Our Case Number: ABP-317560-23

Re: Proposed windfarm development including 13 no. wind turbines in Bunnyconnellan, Co. Mayo and hydrogen plant in Castleconnor, Co. Sligo.
Carrowleagh, Bunnyconnellan, Co. Mayo and Curraun, Castleconnor, Co. Sligo.

RE:. Case number 317560-23
Bartholomew & Jackie Morrisroe

Draft Firlough Wind Farm FRA project number 603676-hydro-RO2-(00) Indicates cabling for underground electrical and communication. These connect the turbines to the wind farm substation - Appendix 9.1 of the groundwater assessment.

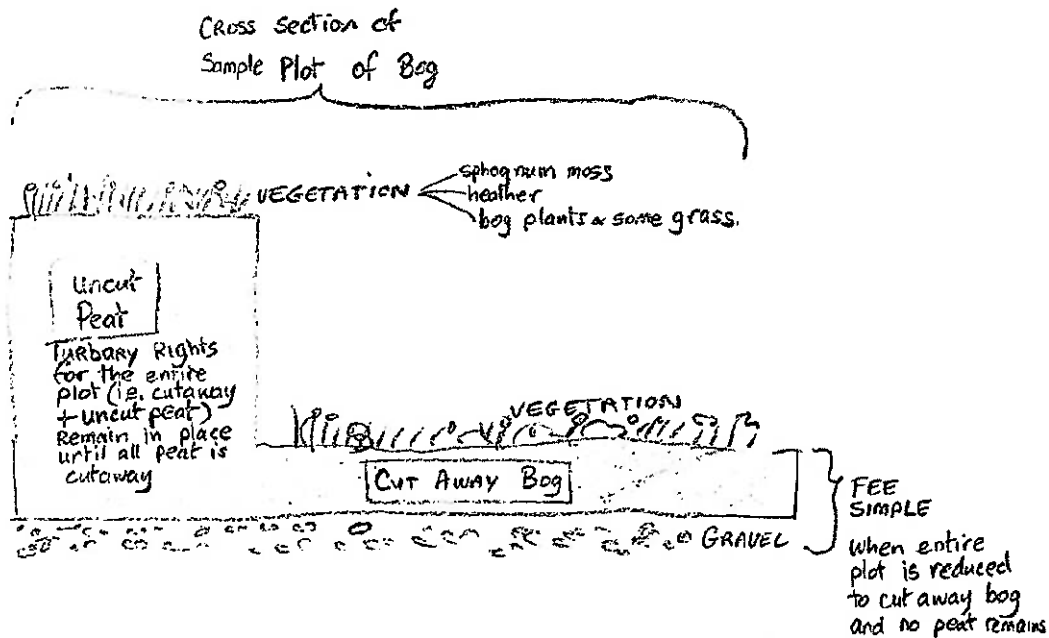
Concern: - Where are the proposal drawings for this underground cabling, as the location of these proposed cables may affect turbary rights? Consents need to be in place for this proposal. We can find no letters of consent from owners of these turbary rights.

Sample of how bog plots have been cut in Kilbride bog*

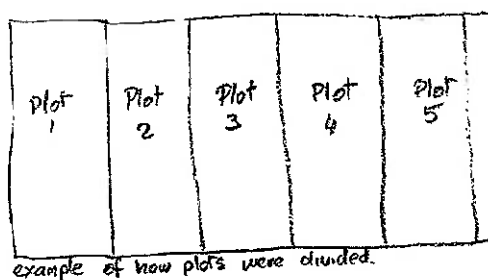
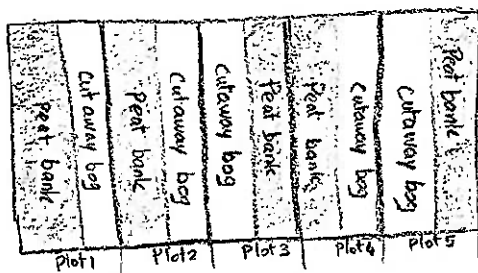
- On Kilbride Bog 'Fee simple' only comes into play on each plot that is 100% cut away. Fully cut away plots then fall under Fee simple
- Turbary RIGHTS remain on each plot where there is still uncut peat & this includes the cutaway portion of each plot in turbary rights.
- Fee simple rights go to Commonage owners

- Turbary Rights to harvest Turf Plots were allocated by number to horses in the area & many to Ballina Town householders
- Bog plots are not typically 50m x 180m as stated by the developer
- There are not over 620 plots as stated by the developer.

- Turbary Rights owners have cut turf on their plots. There is no rule for where they cut on their plots so the pattern throughout the bog is that of plots with strips of peat with strips of cut away bog.
- Therefore Fig. 5.3 does not represent this correctly. Figure 5.3 Habitats map is misleading and shows vast areas of cutover bog.

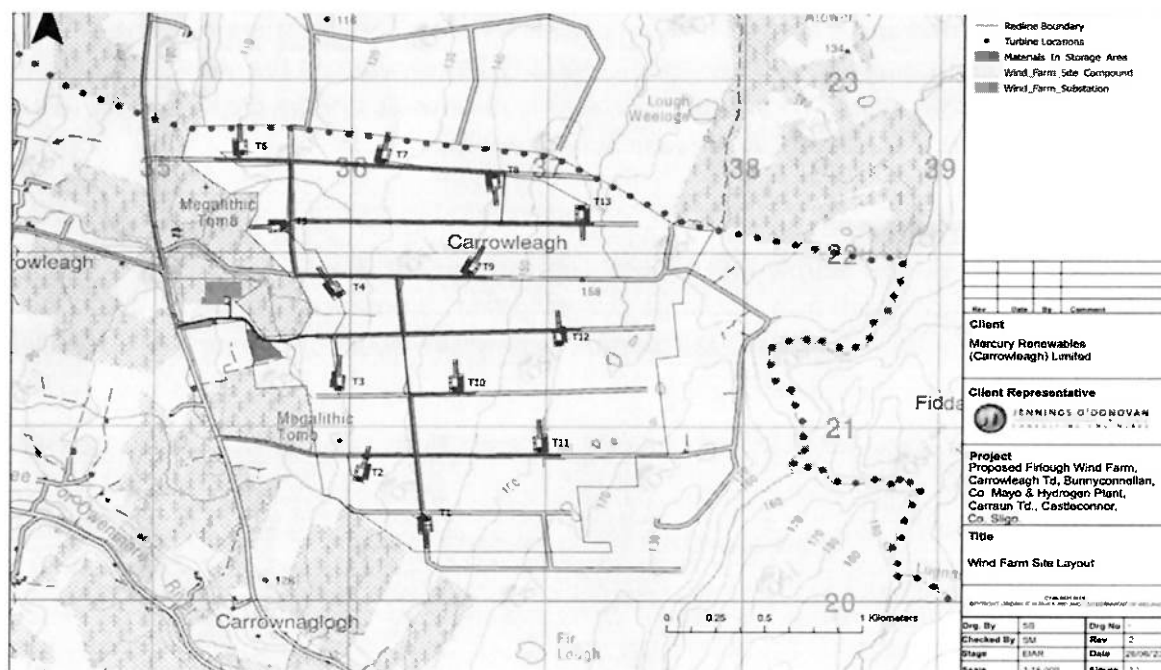
We are gravely concerned in relation to access for approximately 323 turbary plot holders since T2 and T4 have hardstands that traverse two of the access roads to the bog. Firstly, the planning drawings do not show these hardstands and they are portrayed differently in the planning drawings to other turbine bases and hardstands. T4 is not shown in its entirety on a single drawing sheet, in the same manner as the other turbines. Secondly, during the construction phase, it will not be possible to travel over these stands. It is also questionable as to whether people with turbary plots will be able to safely drive over them, with heavy loads, following completion of the project. There is no evidence of consents being in place for turbary plot owners in relation to access to their bog plots throughout the year.

Figure 3.9. SP2 on the 11/07/22 i.e., pre-pumping (left) and after 10 days of pumping 22/07/22 (right).

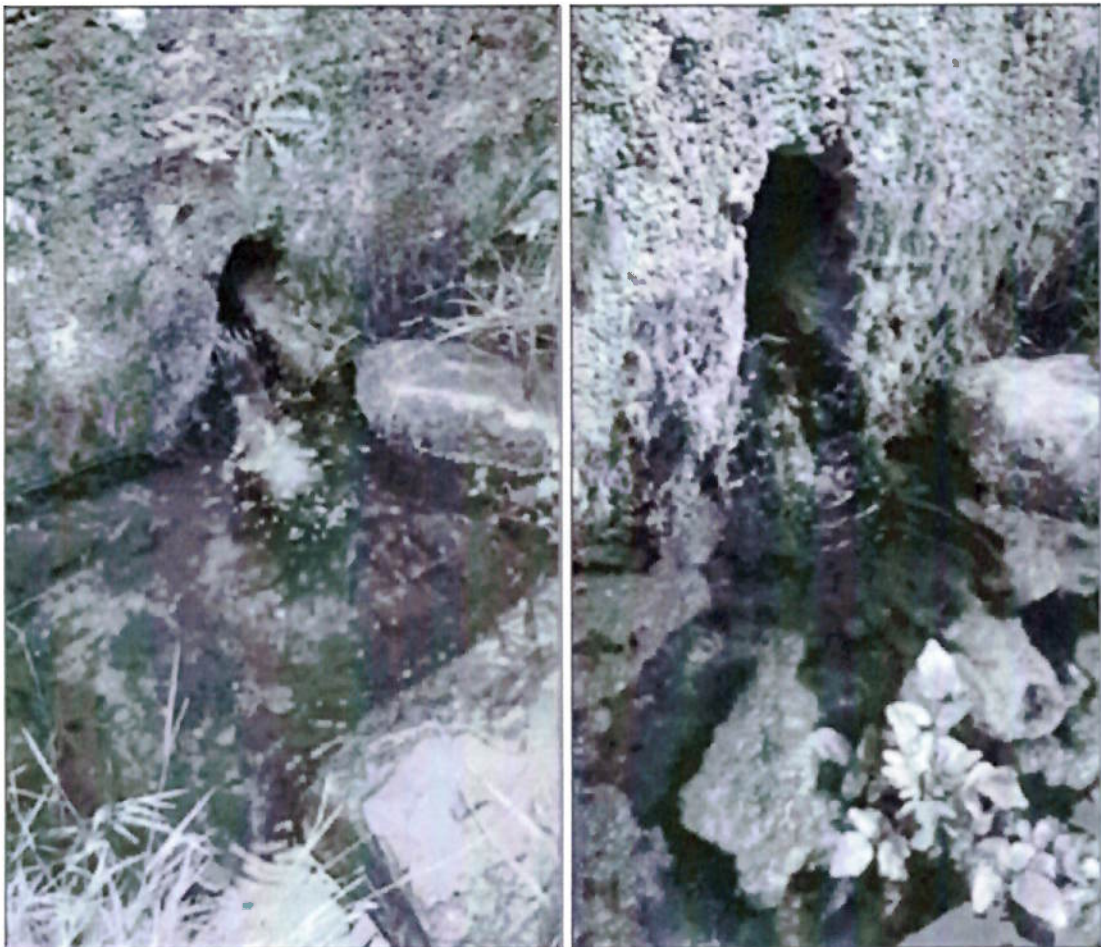
Mercury Quote: - *Reductions in flow at local springs (SP1 and SP2) were noted. However, further investigation would be required to ascertain whether this is due to pumping or low rainfall levels.*

Concern: - We are gravely concerned with these results and that reductions in flow in these springs, resulting from pumping, will have a detrimental affect the local streams leading to the Dooeighney river. The above photos illustrate this after only 10 days of pumping. As very regular harvesters of water from the spring well at the junction of L6611 and the N59, we were concerned at the very noticeable low level of water at the well during this period. Many

people use this water and can be seen drawing it there every day. Why was there no photo included after the completion of testing i.e. after 24 days when it was very low?

Figure 3.8. SP1 on the 11/07/22 i.e., pre-pumping (left) and after 10 days of pumping 22/07/22 (right). Note the very evident decrease in water levels.

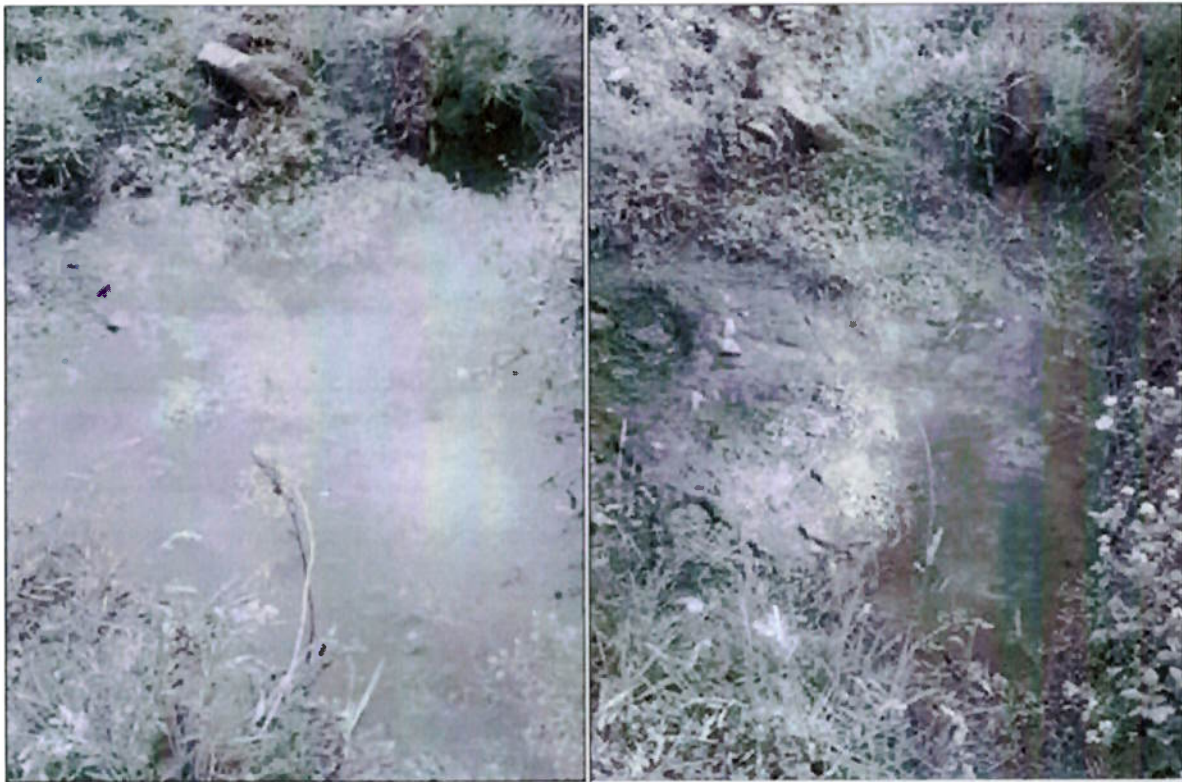
Concern: - In the absence of such a survey, how can this report be acceptable justification that water extraction for the purpose of hydrogen production, won't adversely affect the aquifer and have a knock-on effect on the surrounding area? Why was baseline data not collected re SP1 and SP2 prior to drilling of and pumping from boreholes.

Mercury Quote: - *'Reductions in flow at local springs (SP1 and SP2) were noted. However, further investigation would be required to ascertain whether this is due to pumping or low rainfall levels. A notable reduction in water level/flow was observed at SP1 and SP2 (Figures*

3.8 and 3.9, respectively). Flow at SP2 was measured at 0.65 l/s before pumping, however, it had reduced to 0.3 l/s after 10 days of continuous pumping. Flow further reduced to 0.06 l/s on the 01/08/22 at 8.00, however, it increased to 0.2 l/s by 20.00 on the same day. This is consistent with a heavy rainfall event (approximately 17mm) (see Figure 3.6). 'Flow at SP2 did not increase after the cessation of the pumping test. While flow is apparently somewhat correlated with rainfall, further work would be required to identify the impact of the groundwater abstraction.'
